ETRTO comments on document ECE/TRANS/WP29/GRRF/2009/10(TPMS)

Photo 1: Fatigue cracks on a tyre inner liner, irreversible deterioration of the tyre not visible from outside, resulting from driving on an under-inflated tyre.

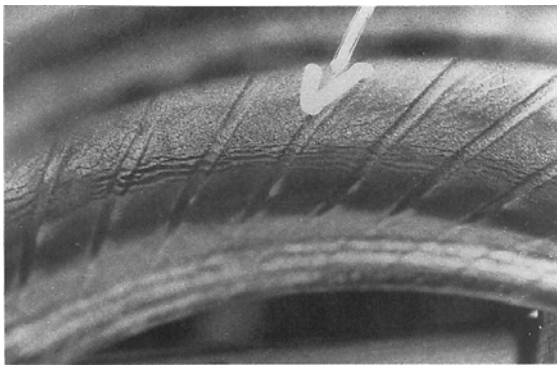
An under-inflated tyre will not fail immediately. It is a matter of time and magnitude of under-inflation and over-loading, until the over-deflection entails cracks in the inner-liner and sidewall. See photo 1.

To control such risks, ETRTO wishes that the second test method for TPMS approval specifies that (1) the test pressure shall not be lower than the minimum cold inflation pressure of the tyre, and (2) the TPMS shall alert in less than 20 minutes.
